REGULAR OPEN MEETING OF THIRD LAGUNA WOODS MUTUAL ARCHITECTURAL AND CONTROL STANDARDS COMMITTEE

**Monday December 27, 2021: 9:30AM - 11:30AM
VIRTUAL/IN PERSON MEETING**

DATE: December 27, 2021
FOR: Architectural Control and Standards Committee
SUBJECT: Variance Request: Mr. Steve Grogan of 5063 Avenida Del Sol (Villa Terraza, Plan C10RC_1) Master Bedroom Extension and Foyer Addition

**ATTACHMENT 1
SCOPE OF WORK**

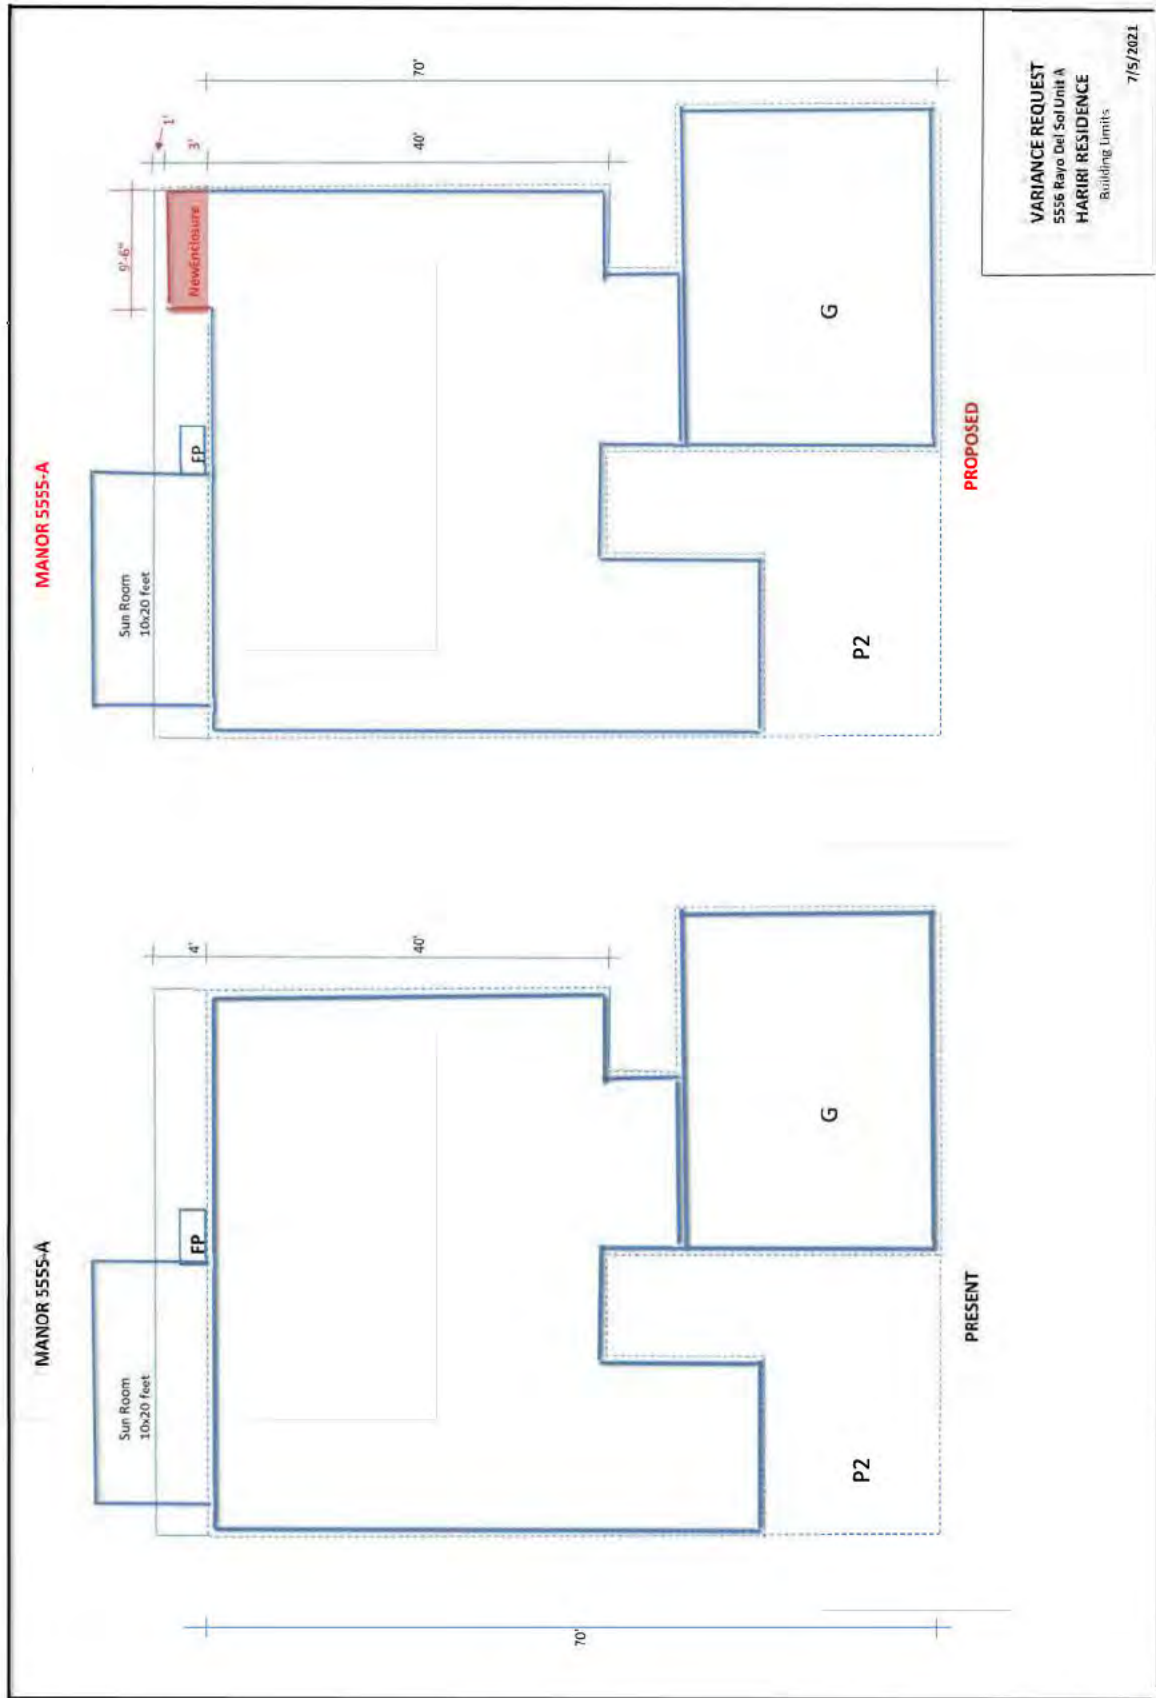
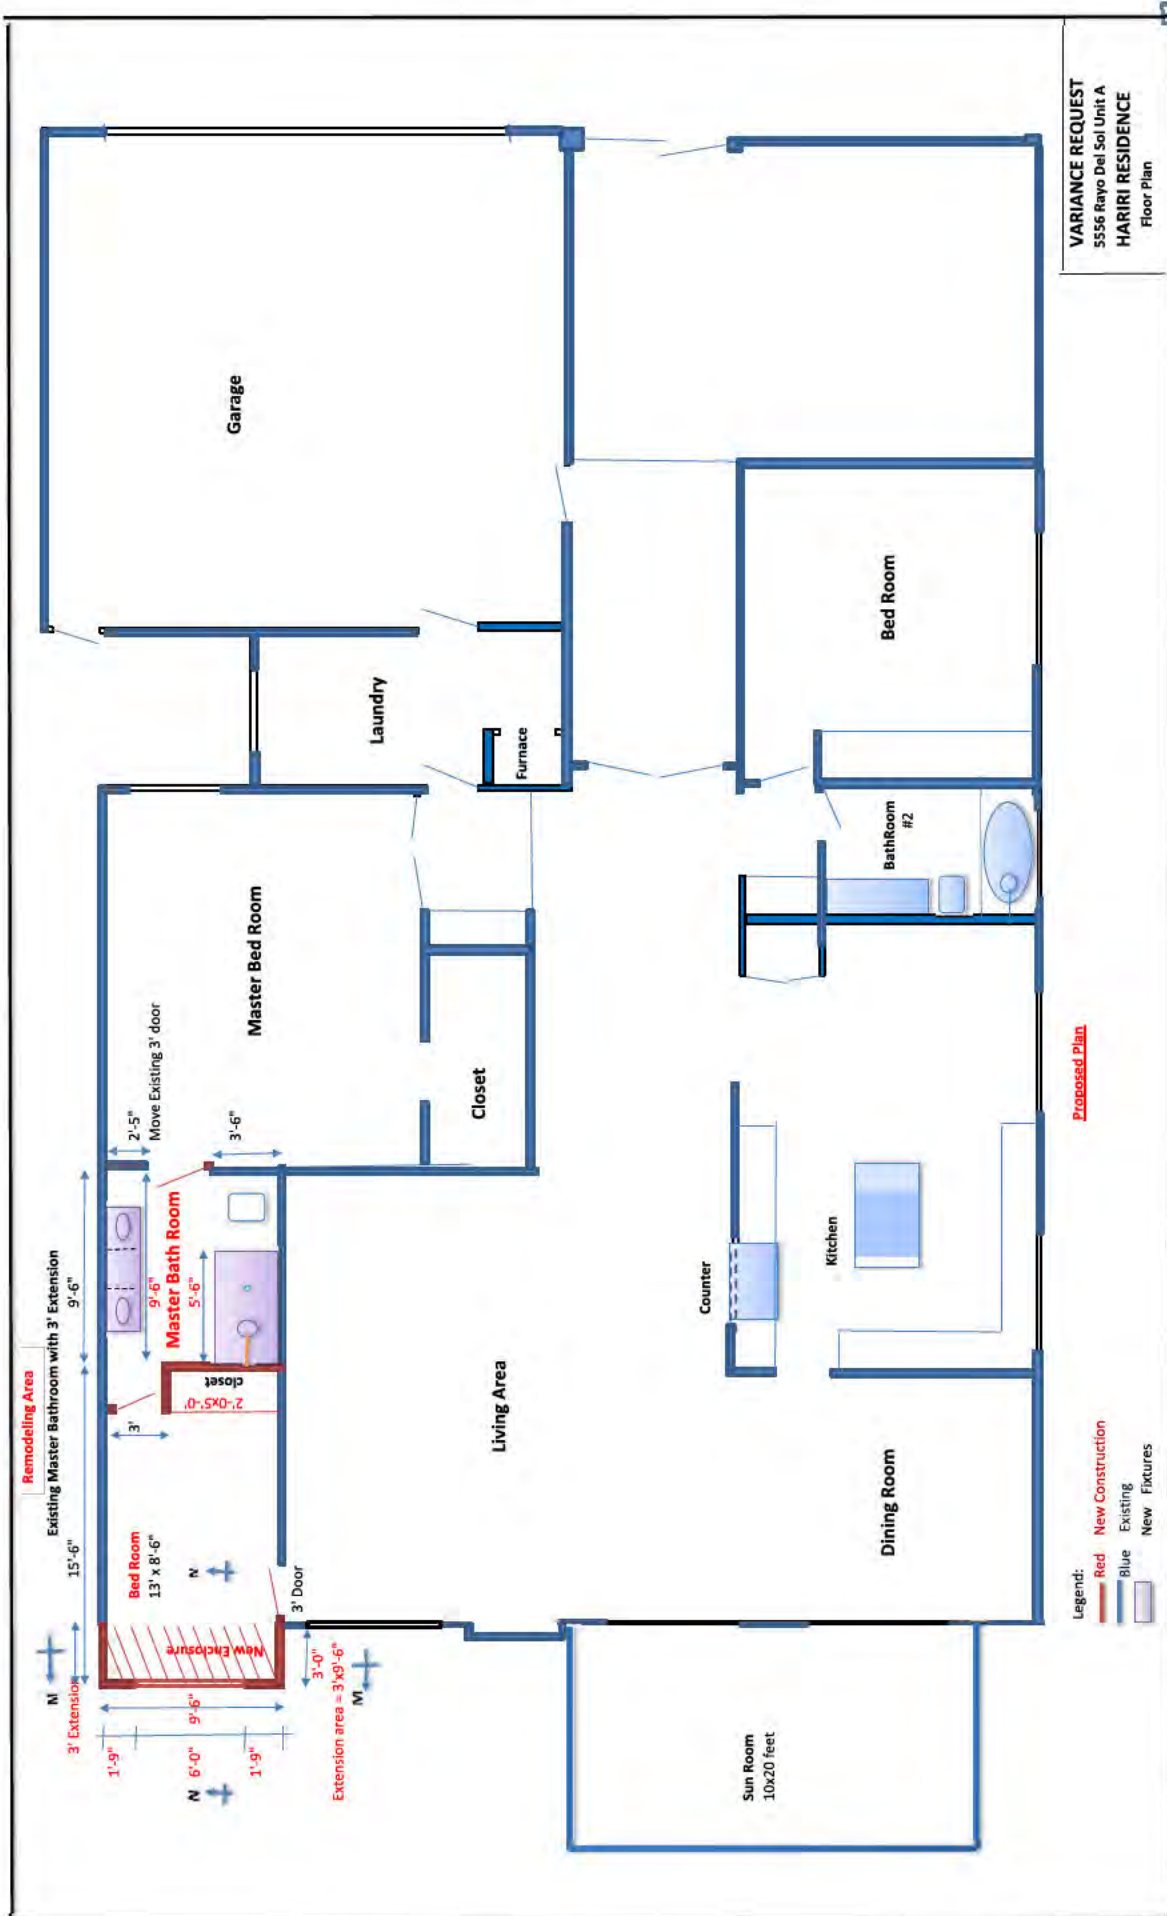
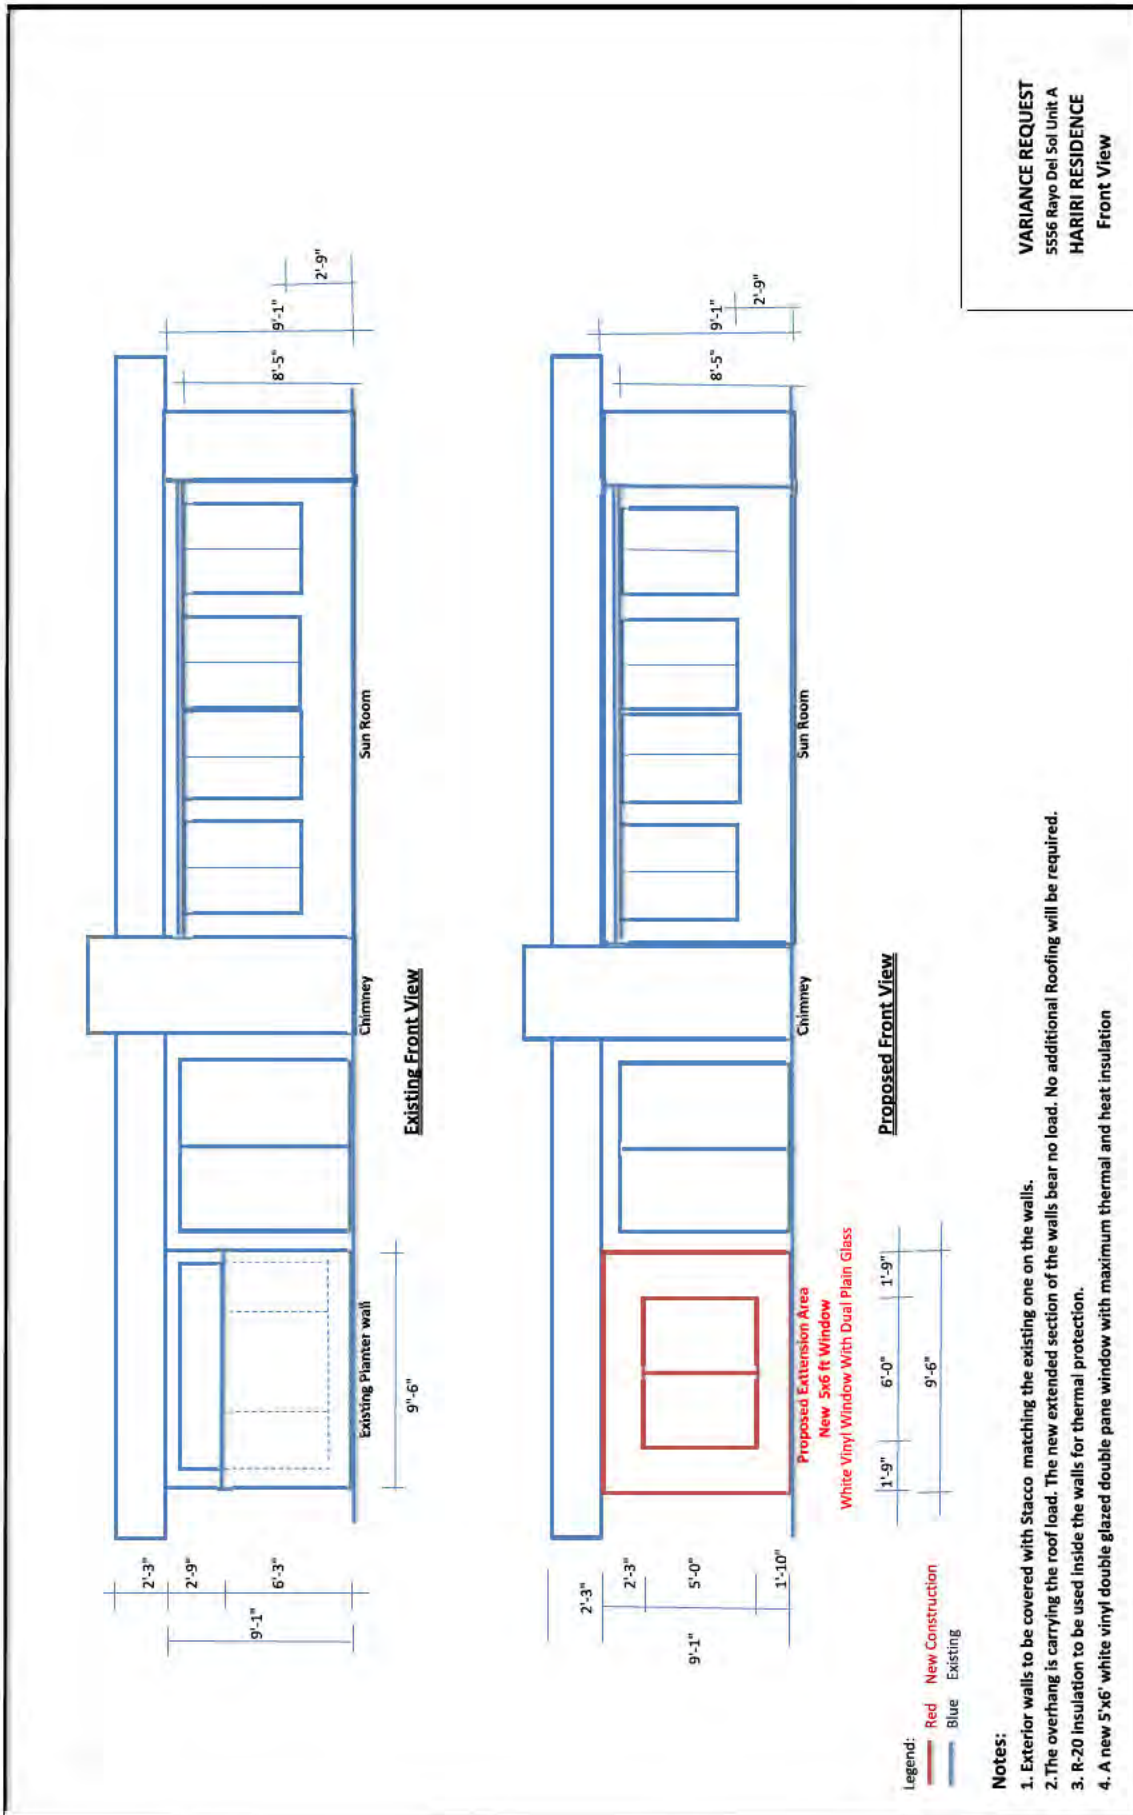
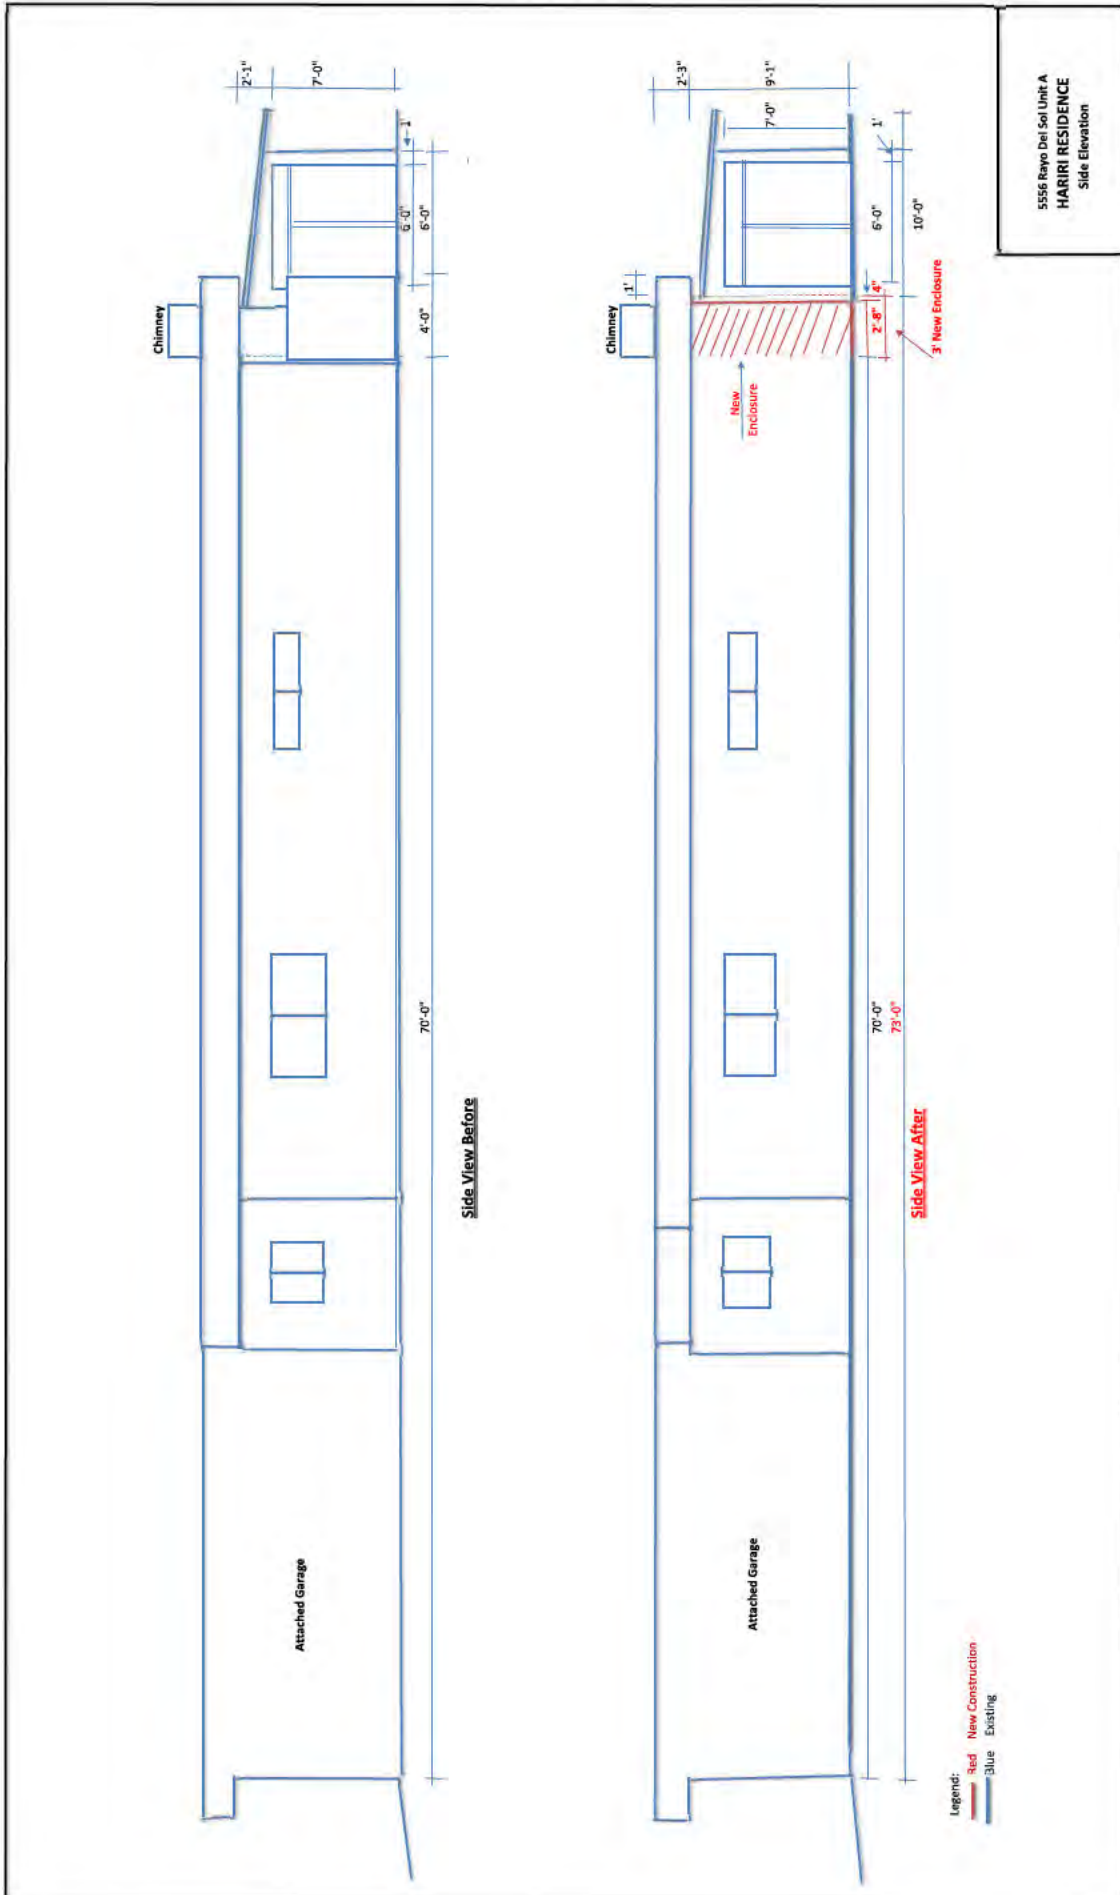
Staff reviewed the submitted documentation and requested architectural drawings for clarification. The resident has indicated that the provided documents are sufficient, and that prior to the approval of the variance, the added expense of providing architectural drawings for a room addition is unwarranted.

- *The submitted proposal for a Variance Request must be **legible, clear and concise and should not require assumptions on the part of the reviewing agent.***
- *The plans must represent a **true replication** of both the existing floor plan and proposed floor plan modifications, scope of work, inclusive of specific dimensional details of each. The plans must identify the precise location of the proposed alteration and any related alterations/installations. For example, if the proposal is for a room expansion, the re- location of doors, if necessary, should be identified.*

The elevations and plans do not accurately reflect the architectural conditions. The description of the new walls not carrying any load, the amount of insulation to be contained within the walls, as well as the overall appearance of the drawings are inaccurate. Without properly drafted architectural plans, it is difficult to determine the extent of the finishes, volumes, profiles, and other construction components of the project.
